South Texas Project Electric Generating Station 4000 Avenue F – Suite A Bay City, Texas 77414

South Texas Project  
Units 3 and 4  
Docket Nos. 52-012 and 52-013  
Second Re-submittal of Response to Request for Additional Information

Re-Submittal of: Letter, Gregory T. Gibson to Paul Kallan, "Response to Requests for Additional Information," dated August 14, 2008 (ABR-AE-08000063).

South Texas Project  
Units 3 and 4  
Docket Nos. 52-012 and 52-013  
Response to Requests for Additional Information

Figure 2.4-1 Landscape Features and Habitat Types of the STP (Source: Reference 2.4-2a)

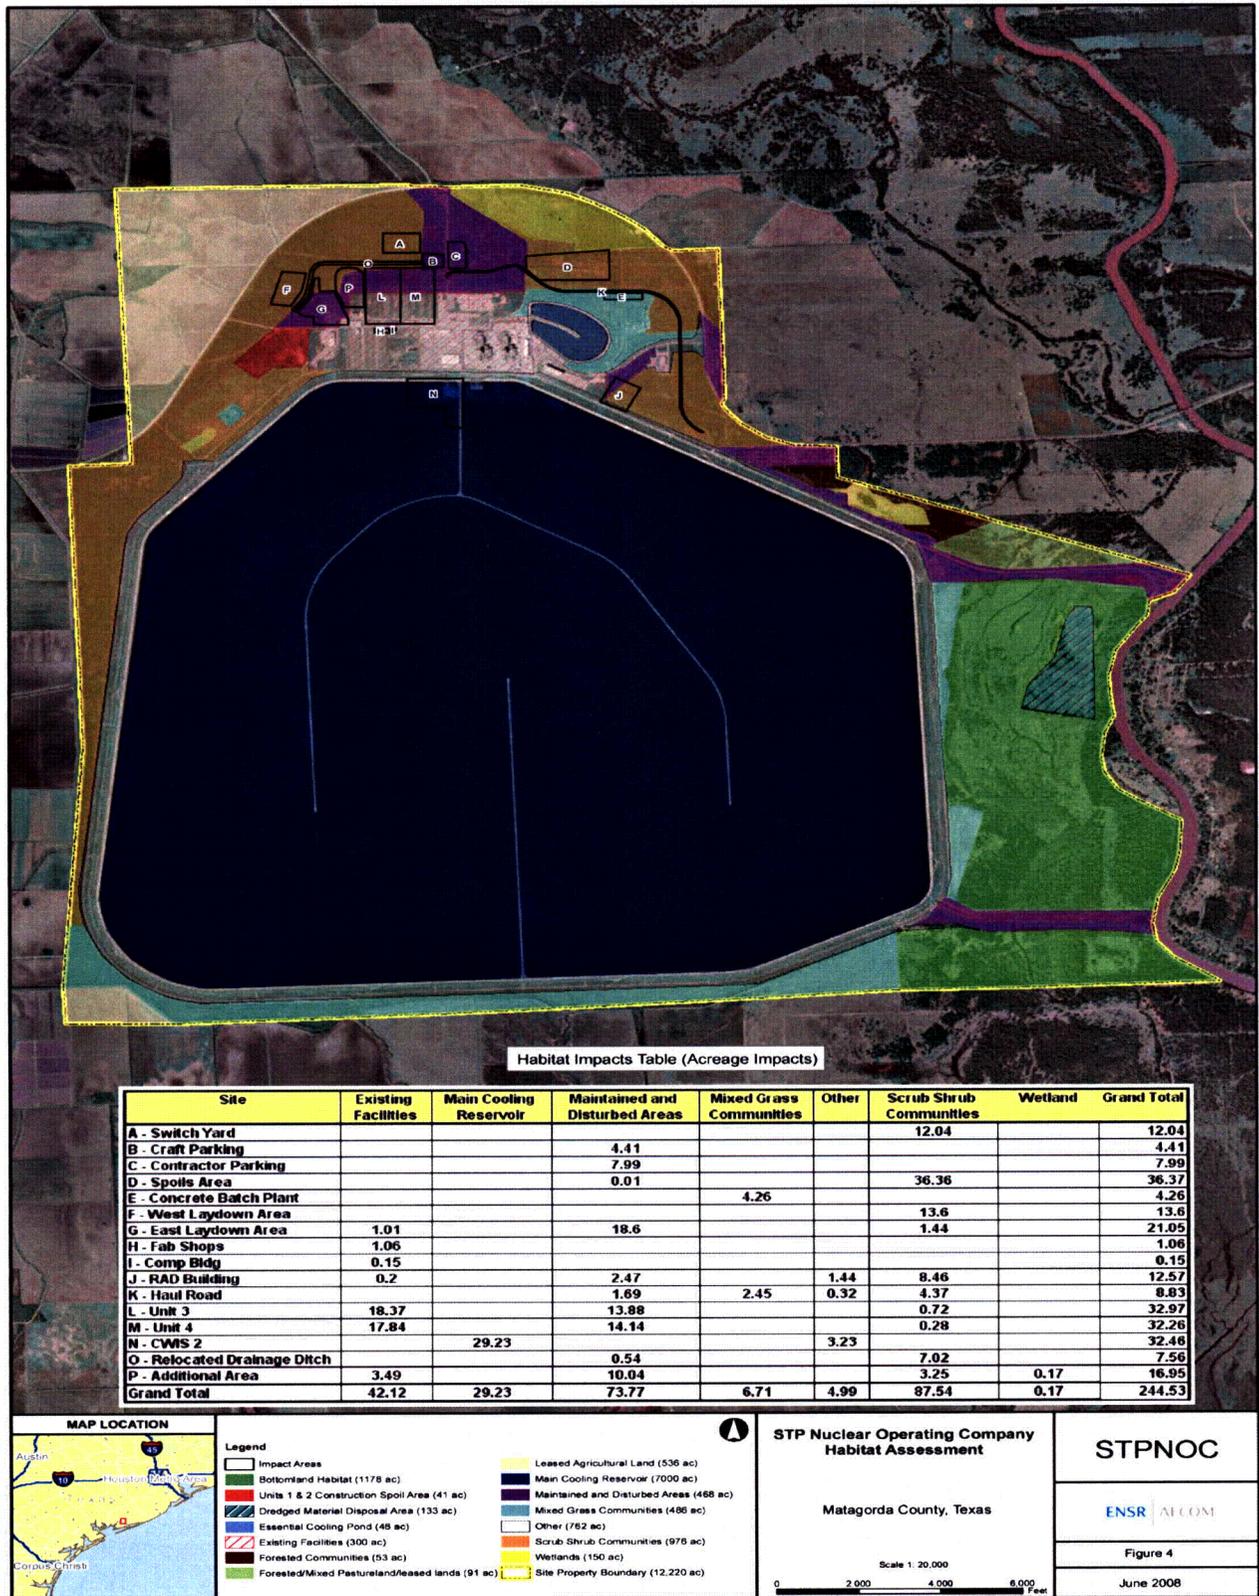
Provide information regarding terrestrial species composition and abundance by habitat type on the STP site.

Provide a description of the dominant and common vegetation and wildlife species found in the habitats existing on the STP site, either as shown in Figure 2.4-1 of the ER, or as described and displayed at the site audit in draft documentation for habitat mapping conducted by ENSR for the applicant. Include information on large and small mammals (including bat species potentially present), common reptiles and amphibians found in the habitats on the STP site and the section of the Hillje transmission corridor to be upgraded. Some of this information is contained in the May 2007, ENSR Corporation Report: 10720-008, but habitat descriptions are not consistent between the ER and the ENSR 2007 report. During the site audit, contractor and applicant staff indicated that a new report describing the habitats on site and the wildlife commonly found in those habitats was under preparation. Provide the finished report.

STP has previously submitted the following reports pertaining to potential wildlife species and vegetative communities at the site in letter # ABR-AE-08000027. These reports included: Ecological Survey Report: Threatened and Endangered Species (ENSR March 2007), Ecological Survey Report (ENSR March 2007), and 1987-1988 Special Ecological Studies for the South Texas Nuclear Project (HL&P March 1989). With this RAI Response, STPNOC submits a copy of the report "Ecological Survey Report-Habitat Assessment" (ENSR June 2008) as Enclosure 1 on the attached CD.

Based on these reports, portions text of the ER will be revised as described below.

3 additional tables will be added and one figure (2.4-1) will be modified

A recent assessment of habitats/land uses within the 12,220-acre STP site reported 14 different habitats (Figure 2.4-1; Reference 2.4-2a). Two of these are open water habitats that occupy a majority of the STP site. The dominant feature of the site is the approximately 7,000-acre main cooling reservoir (Figure 2.4-1) that was established on the property by the construction of tall earthen embankments. The reservoir side of this embankment was lined with "soil-cement" to prevent erosion. Approximately seven miles of interior dikes were placed within the MCR (Figure 2.4-1) to enhance circuitous water flow, maximizing cooling. The Essential Cooling Pond is an approximate 46-acre impoundment immediately to the east of STP 1 & 2, and also is surrounded by an earthen embankment that is covered with reinforced concrete and/or soil cement for erosion protection (Reference 2.4-2b). The external side of the embankment of both reservoirs (approximately 760 additional acres) was planted with grass and is regularly maintained by mowing.
